5	TOLERANCE	Decimal	DATE			 RF & MICROWAVE TECHNOLOGY Tel : 82-32-347-8015 Fax : 82-32-347-8017		
		±0.2	2017. 02. 09.					
	Angle	APPROVED BY						
		±1°	CHECKED BY					
MATERIAL			DRAWN BY	I.C.KIM	TITLE		SMA50 (J) SWD SWITH (P) 2 HOLE ADAPTOR	
FINISH			SCALE	UNIT		A4	DWG NO.	AD00190-7/5
			3/1	mm			REVISION	5

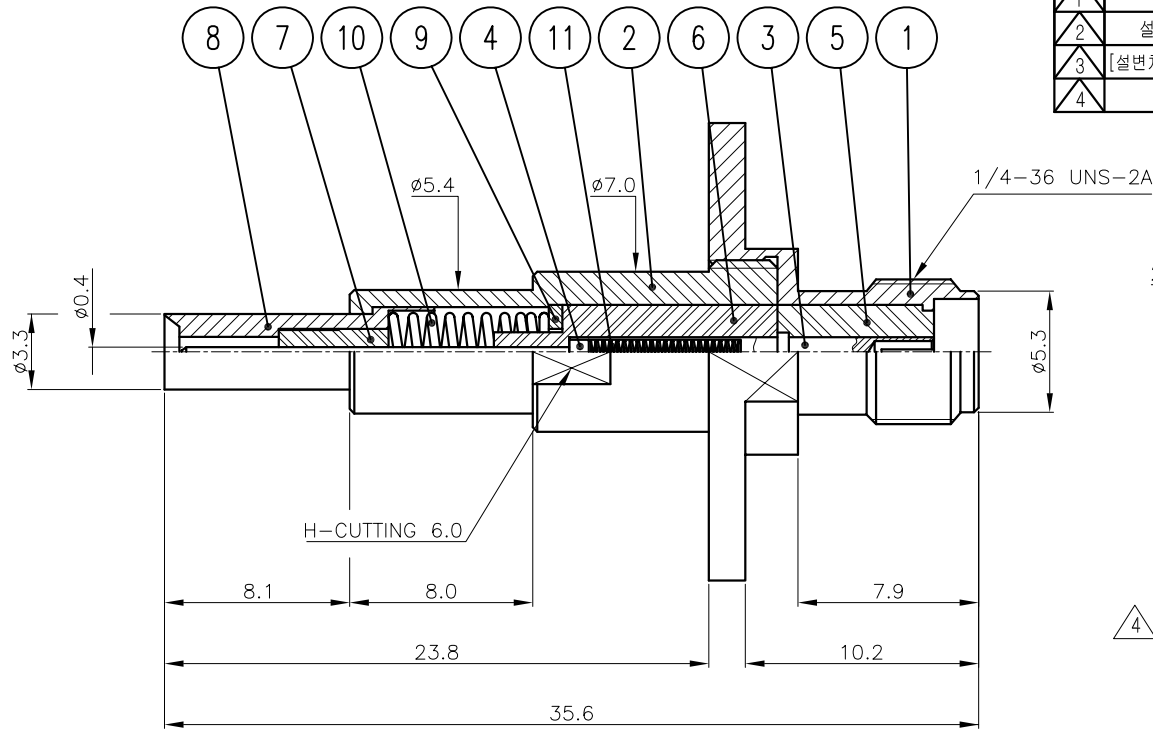
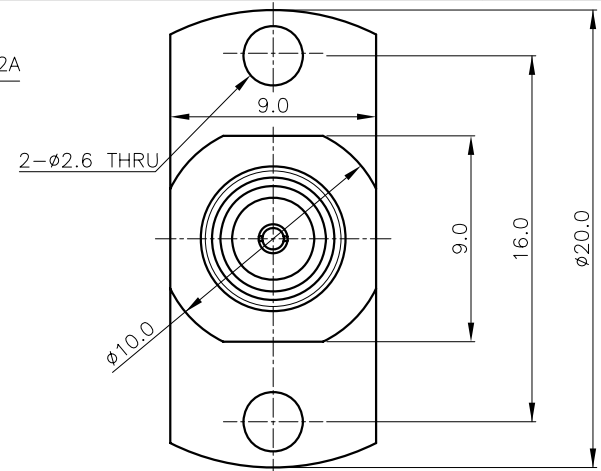
REV	DESCRIPTION	DRAWN	APPR	DATE
IR	Initial Registration			2009.09.03.
1	절연체 가공 어려움에 따른 형상변경 설변			2010.02.22.
2	설번처리No.201009-0007 (SPRING 길이 및 강김수 변경)			2010.09.27.
3	[설번처리No.201102-0007] 절연체 형상 및 치수 변경 신규 코드등록	I.C.KIM	Y.H.CHOI	2011.02.18.
4	가공업체 요청으로 스프링 외경 변경 및 PIN 내경 변경	H.J.LEE	I.C.KIM	2015.12.29.
